TO: Planning & Zoning Commission
FROM: Heather Valone, Village Planner
THRU: Jeffrey Stein, Deputy Village Administrator
SUBJECT: Case 2001-15 Look Nu Carwash
DATE: January 13, 2017

Case No. 2001-15
Project Name Look Nu Carwash PUD Amendments

PROPOSED FLOOR PLAN
 1/16"=1'-0"

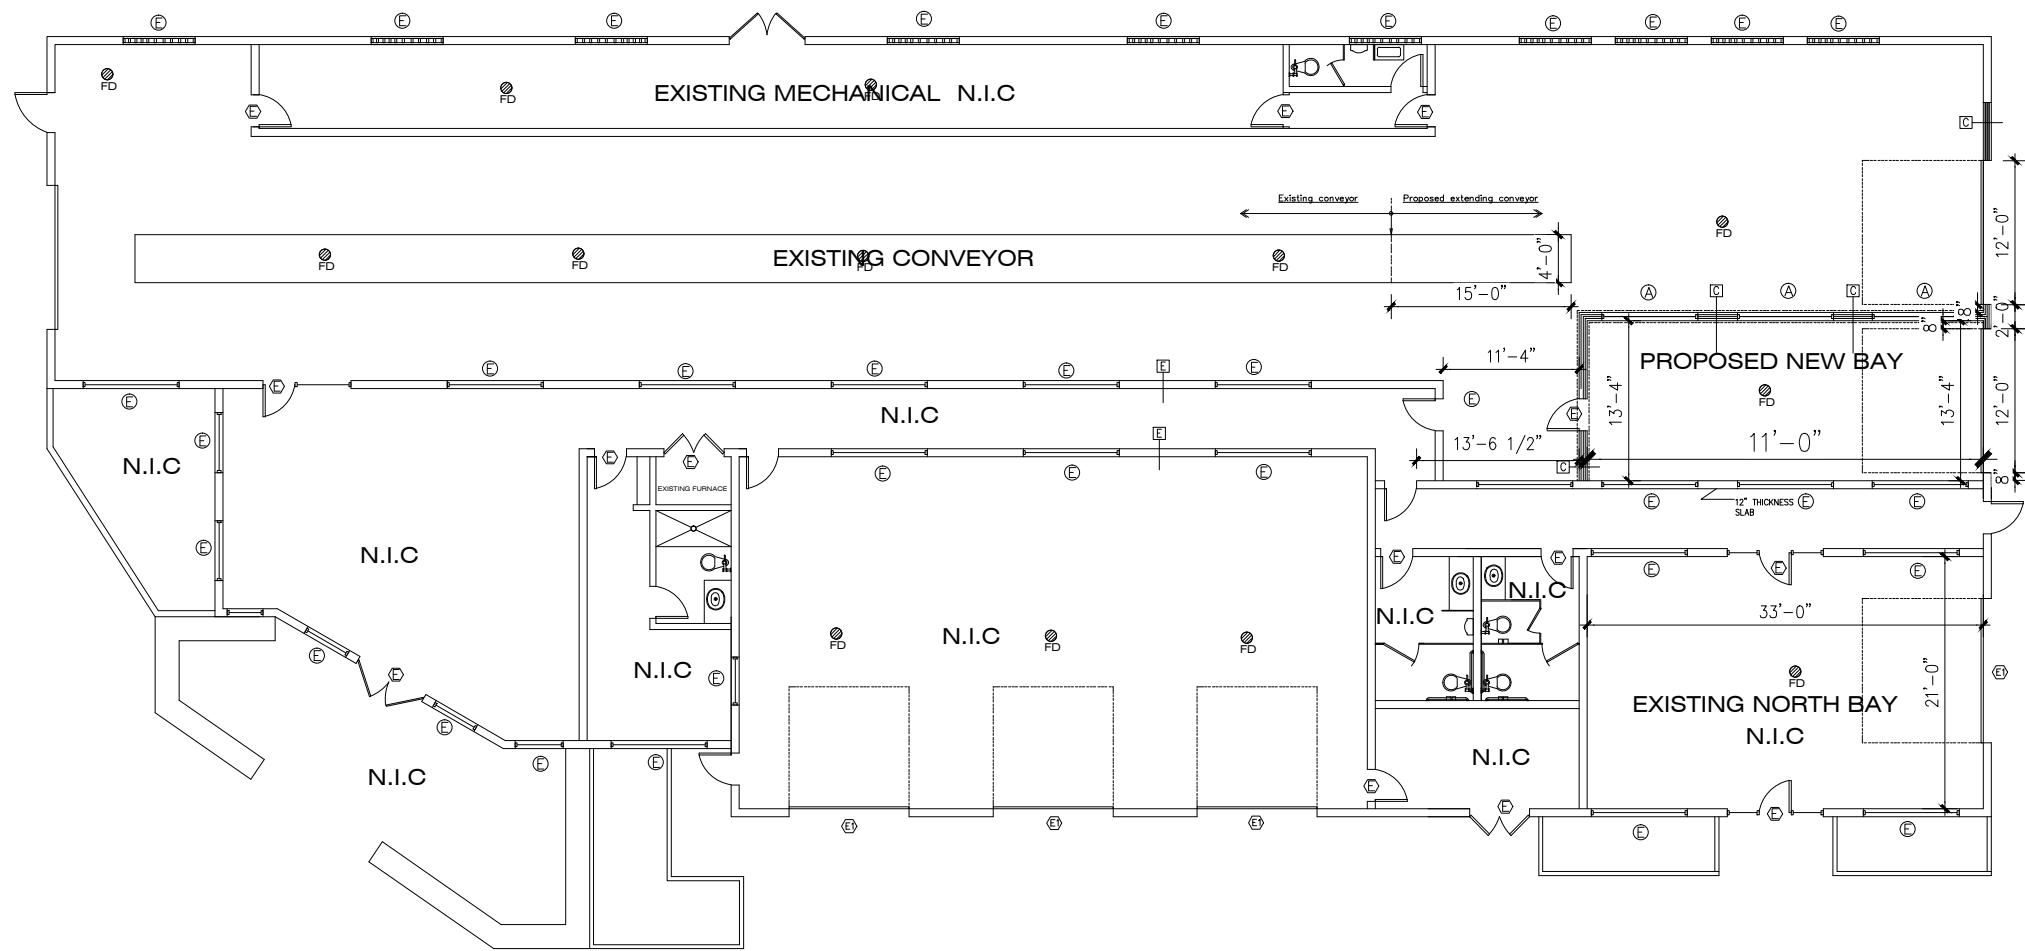
3.7	All operations shall be indoors, except car parking, queuing, and hand drying of vehicles	The applicant is proposing six (6) outdoor vacuuming stations and three semi-outdoor vacuuming stations in the entrance of the detailing bays	Staff finds the deviation for the vacuuming stations outside as proposed with the vacuum unit outside unacceptable. Please see the table above for more information. Staff finds this deviation for the vacuuming stations semi-outdoor at the entrance of the detailing acceptable. The noise generating vacuum unit is in housed inside the building the noise generated at the entrance of the detailing bay is minimal.

The outdoor vacuuming stations near the exit of the wash along the south property allows for drive aisles that meet UDO standards for two-way traffic. The proposed vacuuming stations are equipped with an arm with a hose and dust bin, trash can, and canopy over the vehicle. The equipment is gray and blue. Staff is recommending that the canopy be removed and the equipment either be a neutral, gray, or black color.

The proposed amendments are consistent with the Lemont 2030 Plan. There are no proposed changes to the exterior of the building, queuing, or the existing landscaping. However, the noise potentially generated from the outdoor vacuum unit is a concern. Thus staff is recommending approval with the following conditions:

1. The outdoor vacuum unit must be revised to either utilize different equipment, utilize sound reducing equipment to meet the 57 maximum permitted decibels per the UDO, or the vacuum unit must be moved to the interior.
2. The canopy on the vacuuming stations must be removed and all the outdoor vacuuming station equipment must be either a neutral, gray, or black color.
3. The applicant will comply with a landscaping inspection for the exiting landscaping.
